**RECEIVED** UNITED STATES **OCD-HOBBS**  
DEPARTMENT OF THE INTERIOR  
BUREAU OF LAND MANAGEMENT  
**DEC 2 8 2009**  
**HOBBSOCD** NOTICES AND REPORTS ON WELLS  
*Do not use this form for proposals to drill or re enter an abandoned well. Use Form 3160-3 (APD) for such proposals.*

Yates Petroleum Corporation plans to plug & abandon this well as follows:

Well Name: West Lynch Deep #1 Field: \_\_\_\_\_

**West Lynch Deep Unit 1  
30-025-26952  
Yates Petroleum Corporation  
December 22, 2009  
Conditions of Approval**

DATE: 10/21/09 WLYNCH1

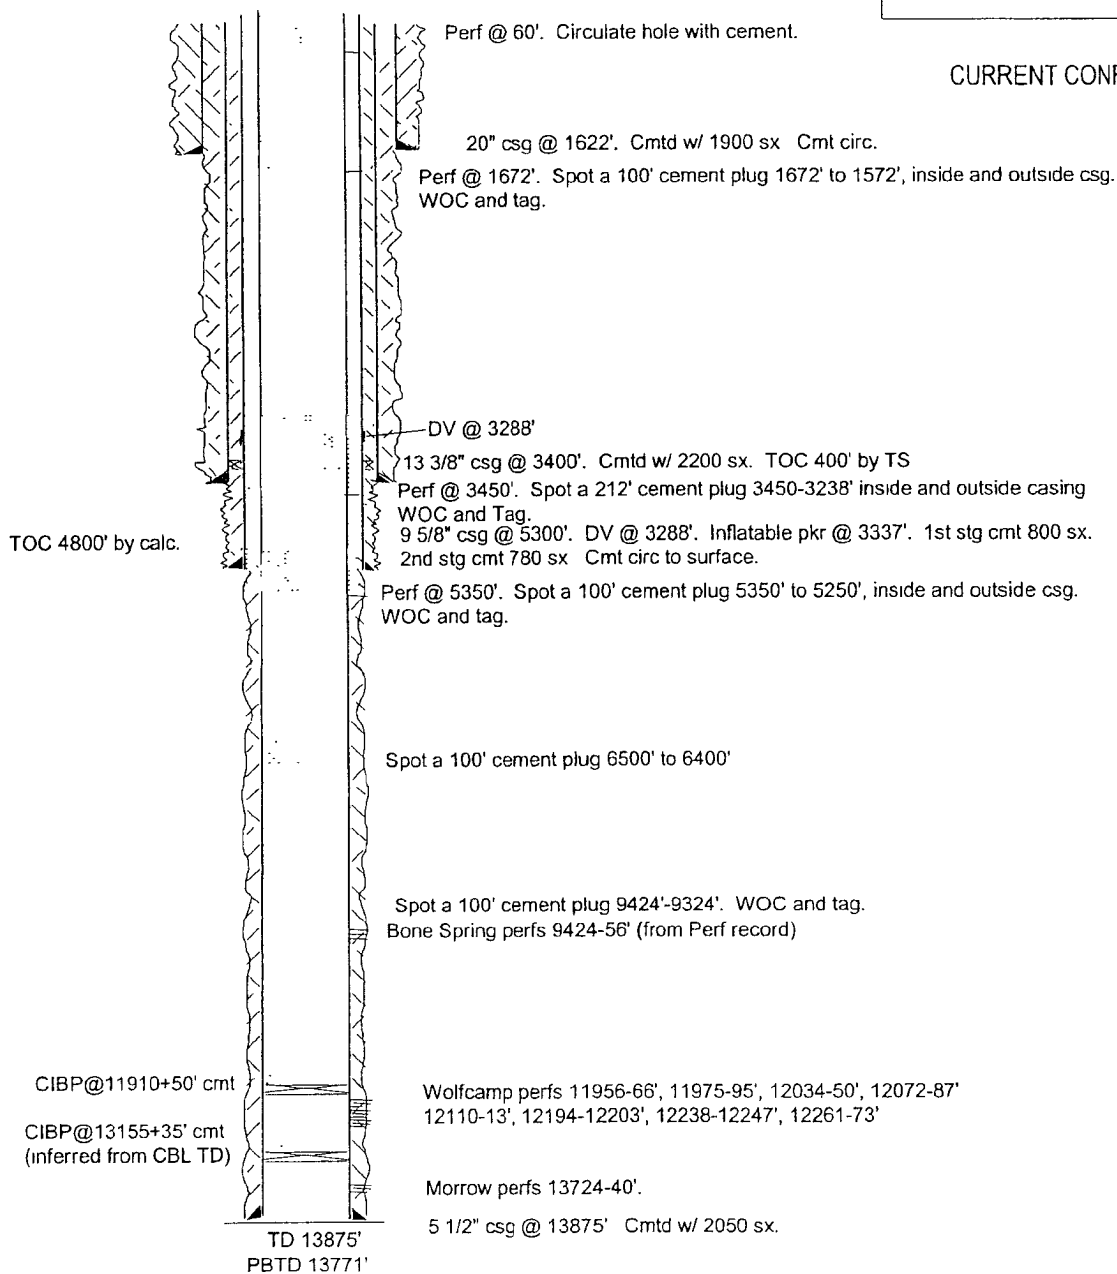
1. OK
2. Note depth of tag for PBTD.
  - a. Plug required at top of Wolfcamp formation. Plug to be 210' in length and a minimum of 25 sacks. Plug to be set from 11356' – 11146'.

- b. Plug must be a 195' in length and a minimum of 25 sacks. Plug to be set across the perforations from 9506' – 9311'. Plug to be tagged at 9324' or shallower. (Bone Spring perfs).

- c. Plug required at top of Bone Spring formation. Plug to be 190' in length, a minimum of 25 sacks and set from 8670' – 8480'.
3. Set this plug from 5,821' – 5,661' to isolate top of the Delaware at 5,771'. Plug to be 160' in length and a minimum of 25 sacks.

4. Plug to be a minimum of 150' in length and a minimum of 25 sacks. Tag at 5200' or shallower. (9-5/8" shoe)
5. OK – Tag at 3238' or shallower. (13-3/8" shoe & DV Tool)

- a. Well is located within R-111-P potash. A solid plug is required from the Base of the Salt to the Top of the Salt (3288' – 1777').
  - b. Perforate 10' above the tag in Step 5, attempt to establish circulation to the surface. If circulation can be established, circulate cement to the surface. Then place solid plug from approximately 3238' to 1572'. WOC and tag.

- c. If circulation cannot be established, pump 25 sacks. WOC and tag. Perforate 10' above tag and repeat step 5b. Continue until plug reaches 1572'.

6. Original step 6 will be covered by the plugs in Step 5.
7. OK – Surface
8. OK
  - a. 13-3/8" x 20" annulus to be filled when wellhead is cut off.
9. See attached general plugging COA and reclamation procedures.
